International Energy Conservation Code Consensus Committee-Commercial

Meeting Agenda (Draft 4/12/23)

April 12, 2023

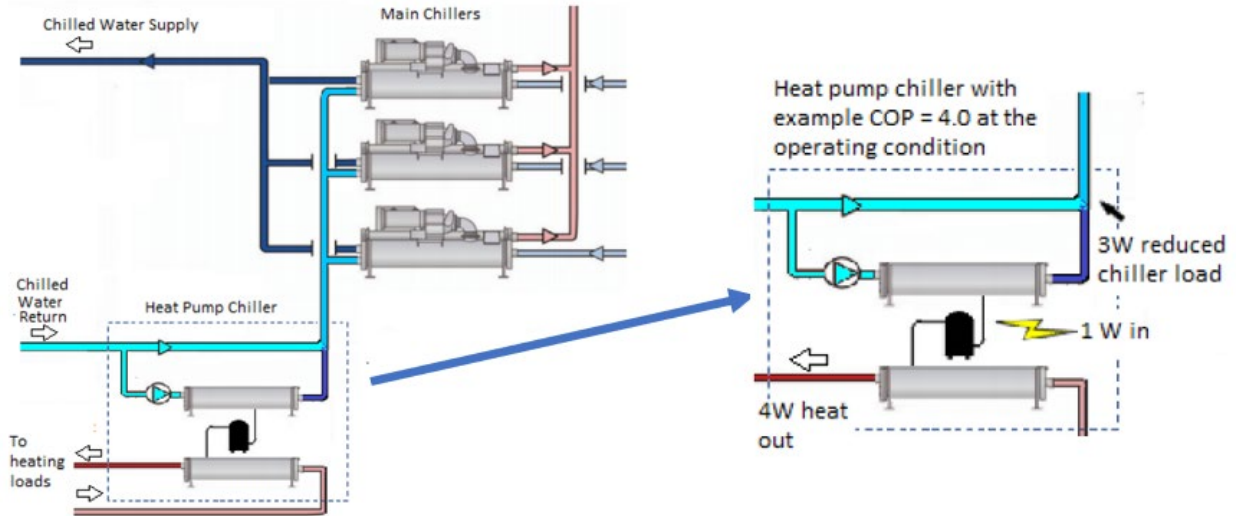
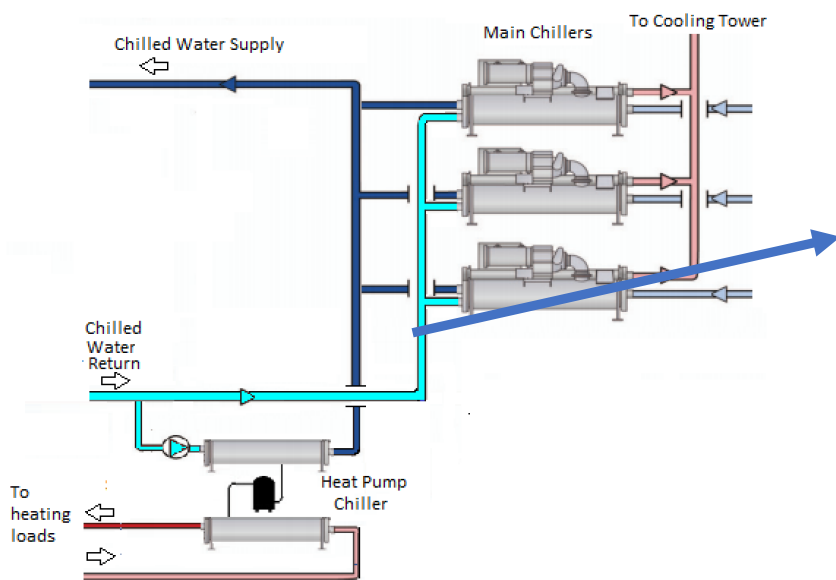
Section C403.11.6, "Heat Recovery for Space Conditioning in Healthcare Facilities," requires heat recovery in most acute inpatient hospitals. The existing language refers to "condenser heat recovery." The heat source was intended to be the chilled water return, and the economic justification was built on that. The diagram shows a parallel and in-series system. Both are acceptable ways to meet the requirement.

The term “condenser heat recovery” has led some users to believe that the heat source can be water leaving the main chiller condenser. While this method does recover heat, it does not reduce the load on the chillers. Using the chilled return water as the heat source saves much more energy.

1. Buildings that provide 60 percent or more of their reheat energy from on-site renewable energy or other site-recovered energy. *On-site renewable energy* used to meet Sections C405.15.1 or C406.3.1 shall not be used to meet this exception.
2. Buildings in Climate Zones 5C, 6B, 7₁ and 8.
